The Corporation of the
Town of Milton
Committee of Adjustment and Consent

Thursday, April 30, 2026, 6:00 p.m.
Council Chambers - In Person

Attachments
Figure 1 - Site Plan

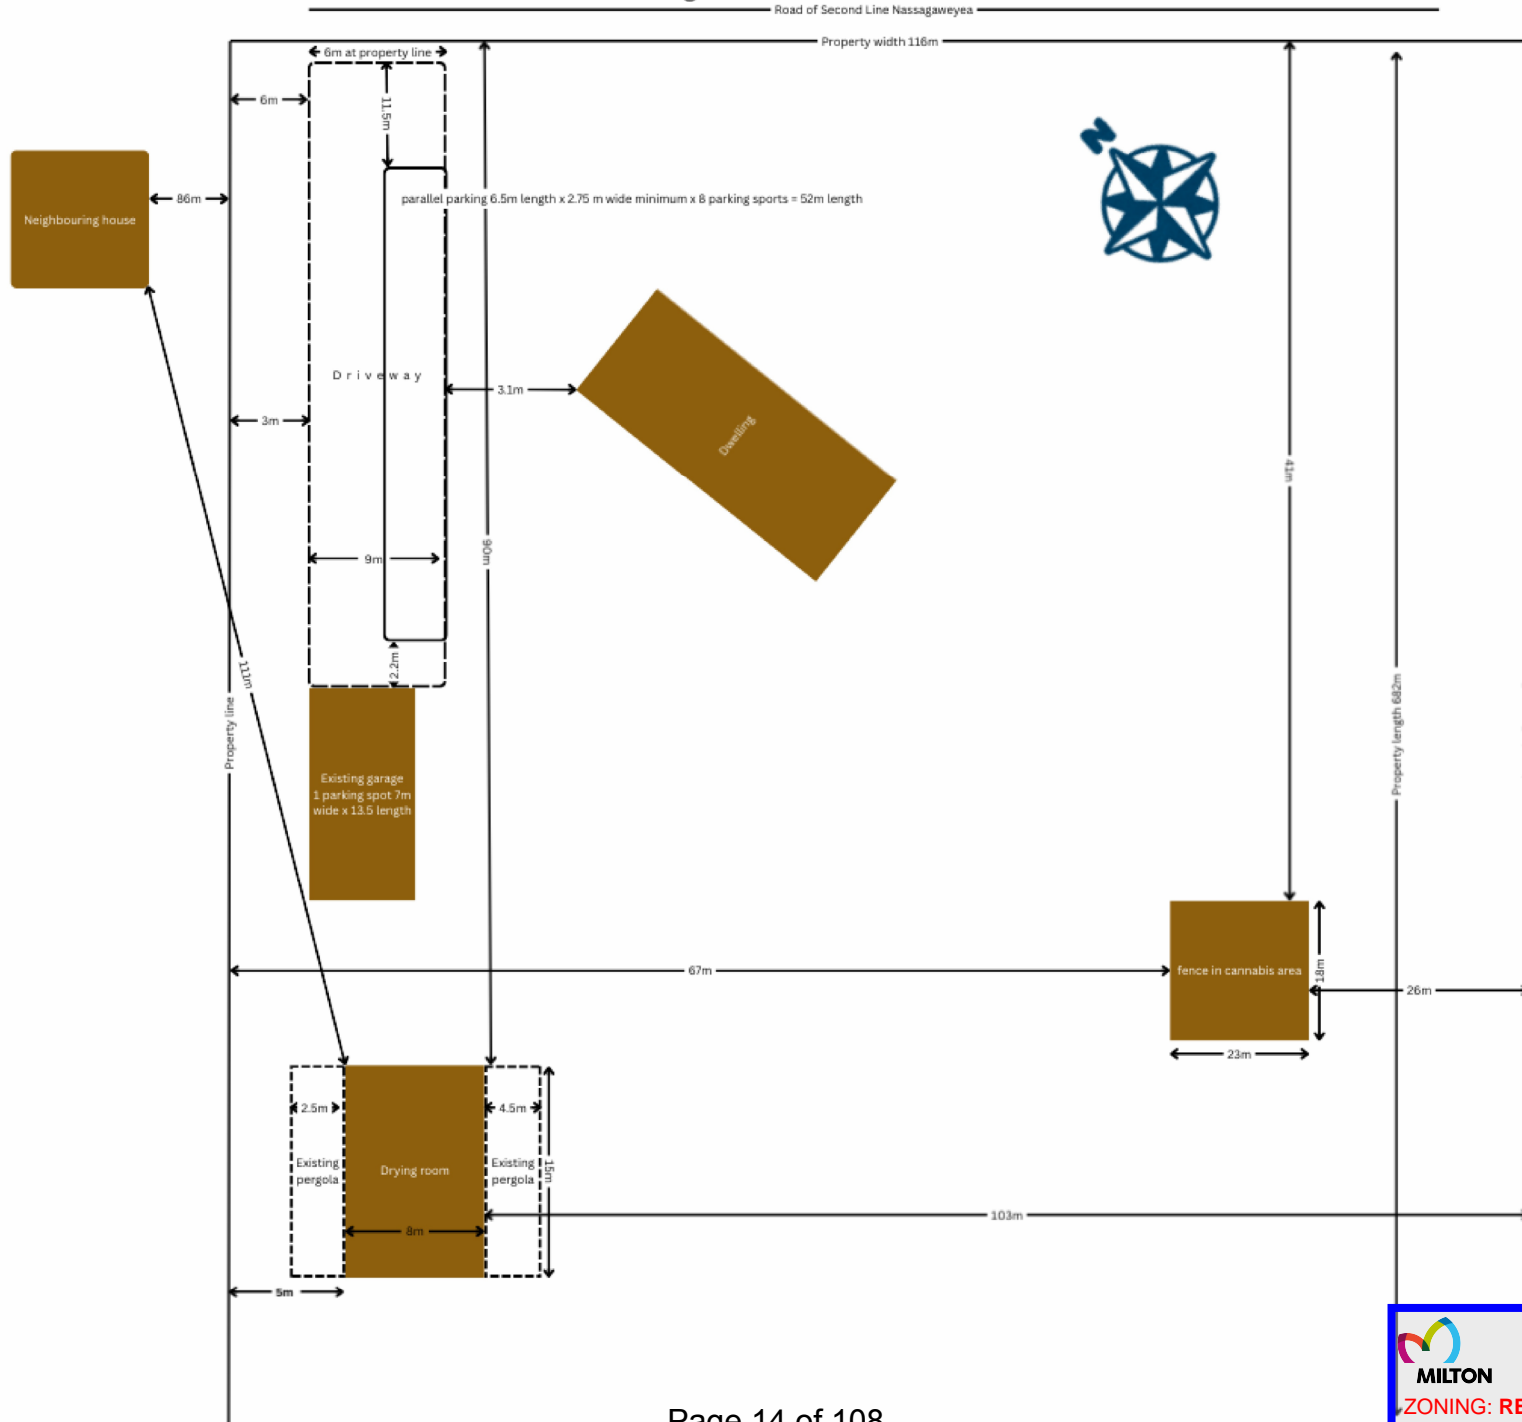
Planning staff note that there is an existing agricultural barn that is located in between the proposed cannabis production area and the nearest dwelling which will provide a buffer and eliminates impact. The current plot of land being used to grow other fruits and vegetables will be utilized and exists as of today and the existing accessory structure will be converted, so there are no new development or changes proposed to the property which will impact any surrounding neighbours or properties.

Attachments
Figure 1 – Site Plan Figure 2 – Architectural Plans

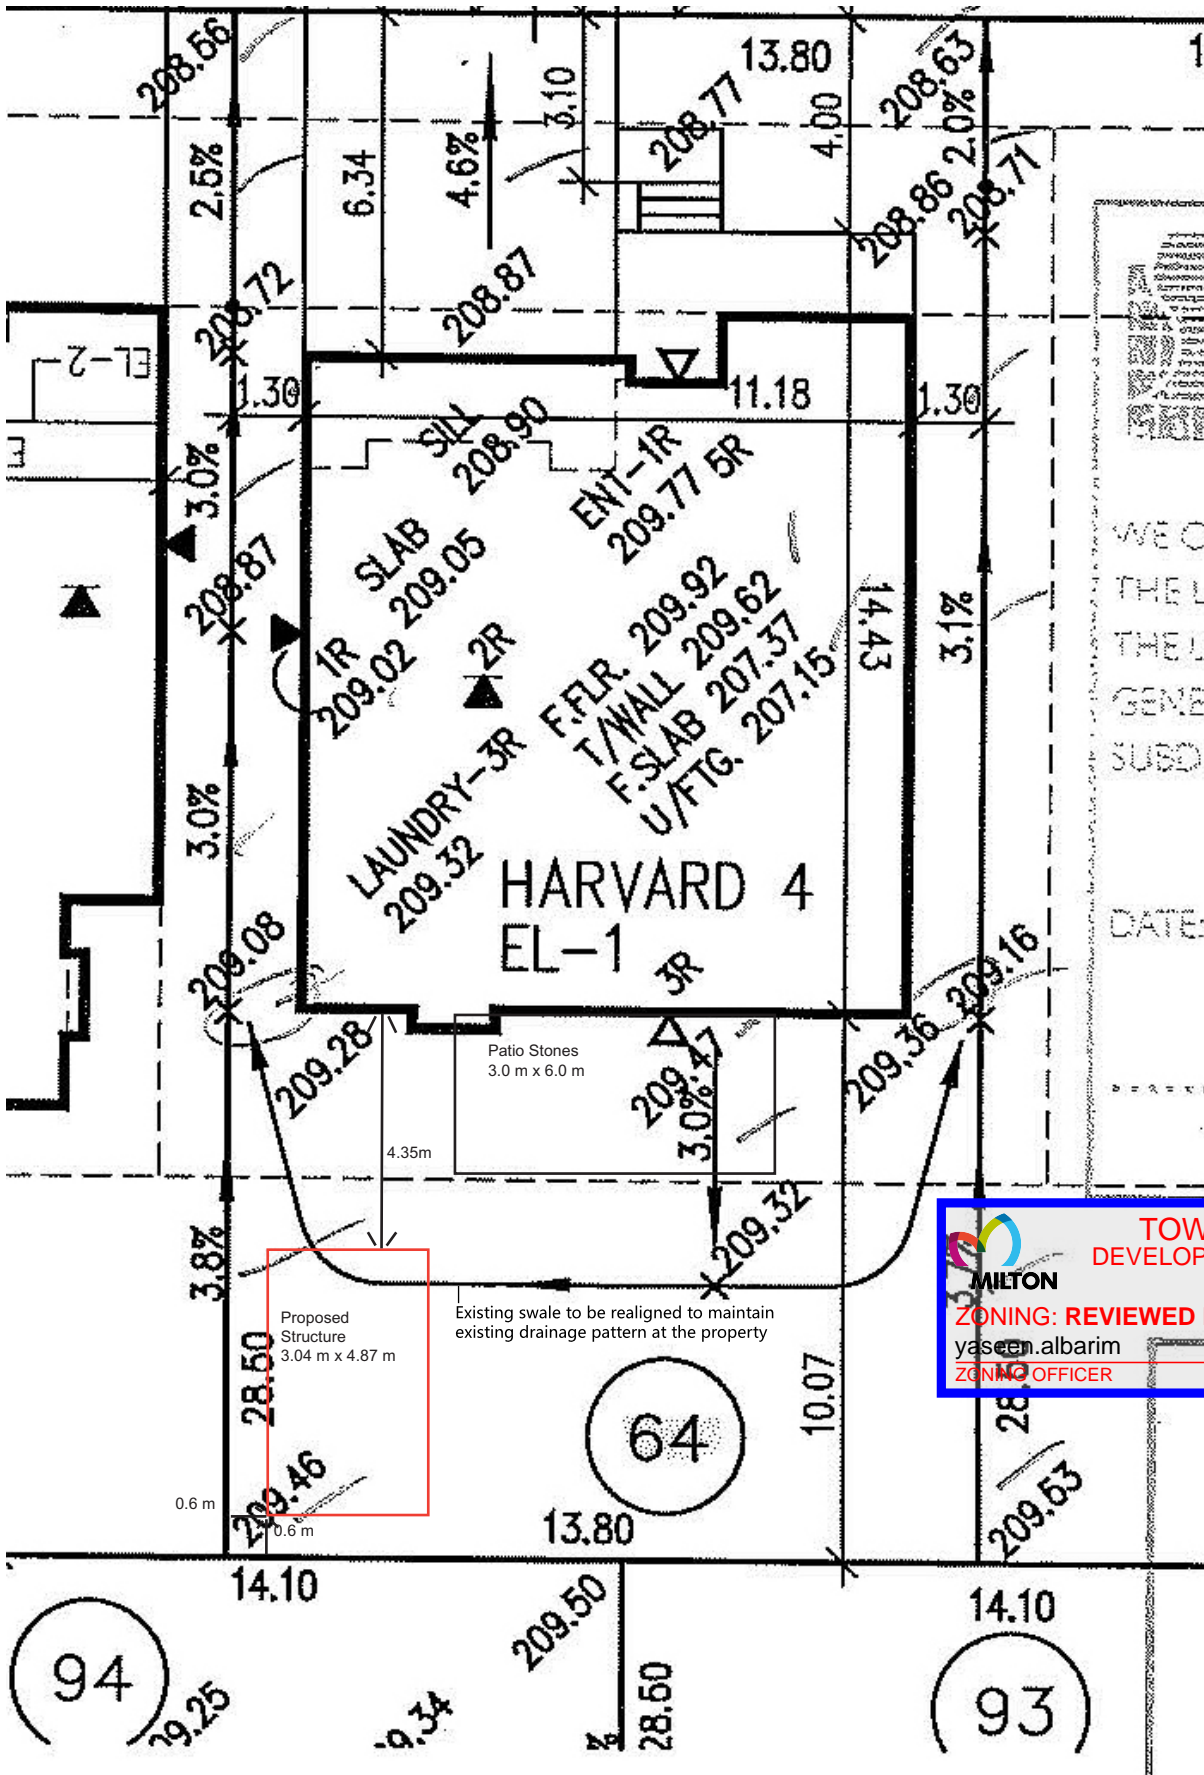
No objections were filed with respect to the variance application from Town staff or external agencies. Development Engineering advised that the location of the accessory structure would conflict with an existing swale; to resolve this issue, the swale will be re-aligned, as noted on the site plan and in the recommended conditions of approval.
